2. Name of Operator
Hilcorp Energy Company

HILCORP ENERGY COMPANY
NEWBERRY A 4
MESA VERDE RECOMPLETION SUNDRY

Attachment to notice of Intent to Recomplete & Commingle

Well: Newberry A4 30-045-12185

Well Name: NEWBERRY A #4

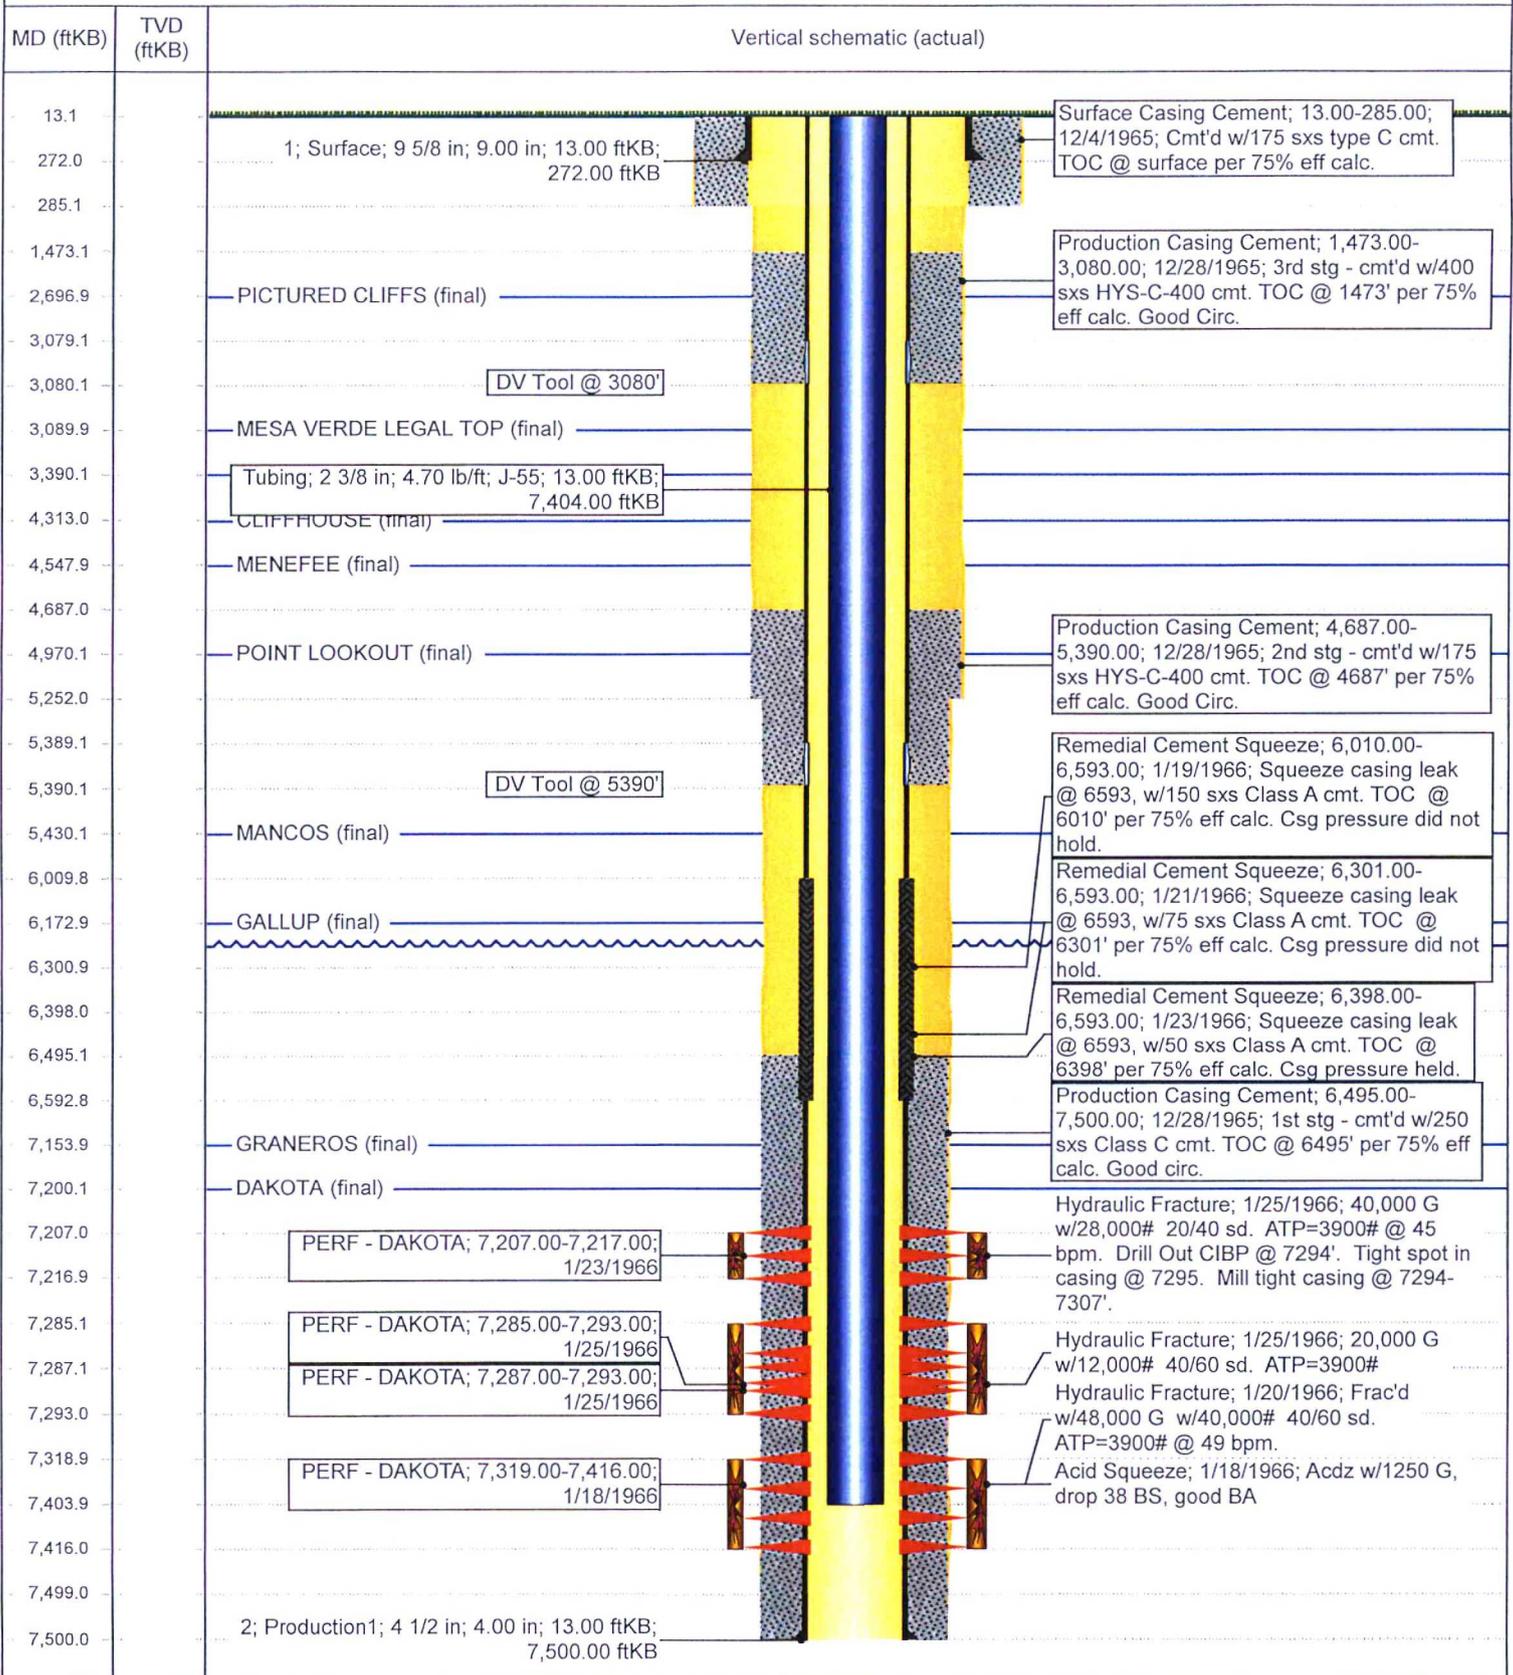
2. The following modifications to your recompletion program are to be made:

- a) Upon rigging up, record Bradenhead pressure and monitor same during recompletion operations. Notify BLM and NMOCD if anomalous pressure changes occur. Provide monitoring results in the subsequent Report of Operations.
- b) Casing pressure test for fracture stimulation operations cannot exceed the internal yield strength of the casing including a 20% safety factor unless a waiver is granted. Stimulation operations cannot exceed this test pressure.
- c) CIBP for base of fracture stimulation to be set less 50' above top existing perforation.
